Detailed Site Plan Alternative Compliance Giac Son Buddhist Temple

DSP-20002
AC-22009

SUBJECT: Detailed Site Plan DSP-20002
 Type 2 Tree Conservation Plan TCP2-018-2023
 Alternative Compliance AC-22009
 Giac Son Buddhist Temple

Figure 2: Institutional Building-Mounted Signage

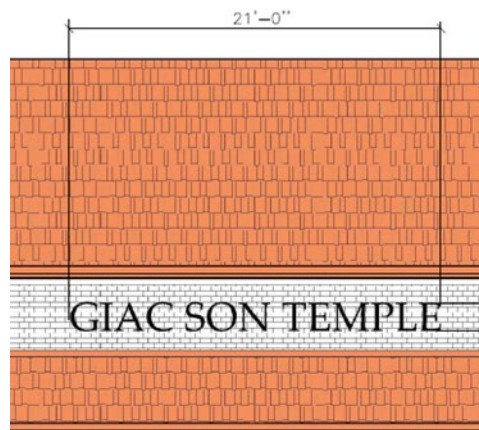
- j. Revise the architectural elevations on Sheet 7 to clearly label the material of the proposed attached signage.
- k. Provide a colored rendering of the freestanding signage proposed on Sheet 10.
